Access Compliance Report Public Rights-of-Way (Curb Ramps)

Main Street: BAUDIN_CIR Cross Street: DE_LEON_LN Location: W

ADA ID: RPRK211112144204 Ramp Type: Type 4 - Parallel Initial Pass/Fail: Fail Overall Compliance: No Severity Score: 32

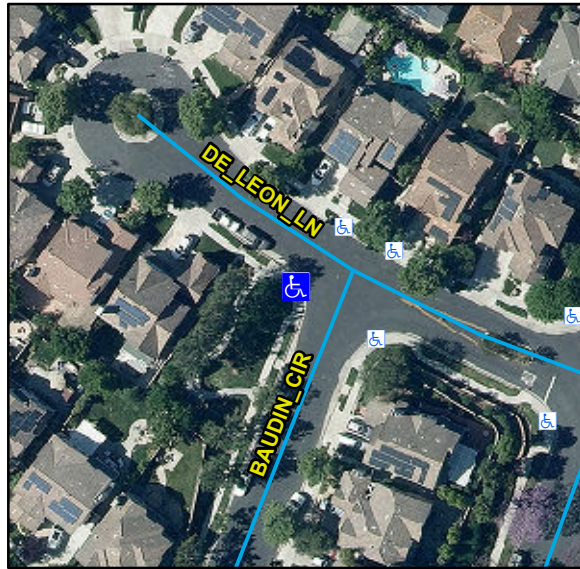
Compliance	Description	Data	Compliance	Description	Data
N/A	Ramp Length LT (in)	130	N/A	Ramp Length RT (in)	130
Yes	Ramp Width LT (in)	55	Yes	Ramp Width RT (in)	55
Yes	Ramp Run Slope LT (%)	1.1	No	Ramp Run Slope RT (%)	12.5
No	Ramp Cross Slope LT (%)	2.1	Yes	Ramp Cross Slope RT (%)	0.5
N/A	Landing Present	N/A	N/A	DWS Provided	N/A
N/A	Landing Length (in)	N/A	N/A	DWS Contrast	N/A
N/A	Landing Width (in)	N/A	N/A	DWS Length (in)	N/A
N/A	Landing Run Slope (%)	N/A	N/A	DWS Full Width	N/A
N/A	Landing Cross Slope (%)	N/A		DWS Offset Type	N/A
N/A	Landing Movement Obstructed?	N/A	N/A	DWS Offset Left (in)	N/A
	Landing Movement Type	N/A	N/A	DWS Offset Right (in)	N/A
N/A	Landing Shared	N/A			
N/A	Clear Space	Yes			
N/A	Clear Space To Crosswalk (in)	N/A			
N/A	Marked Crosswalk 1	No	N/A	Marked Crosswalk 2	No
	Crossing 1 Direction	SE		Crossing 2 Direction	NE
N/A	Marked Crosswalk 1 Width (in)	N/A		Marked Crosswalk 2 Width (in)	N/A

Remove & Replace Curb Ramp With Two New Directional Ramps or Equivalent.
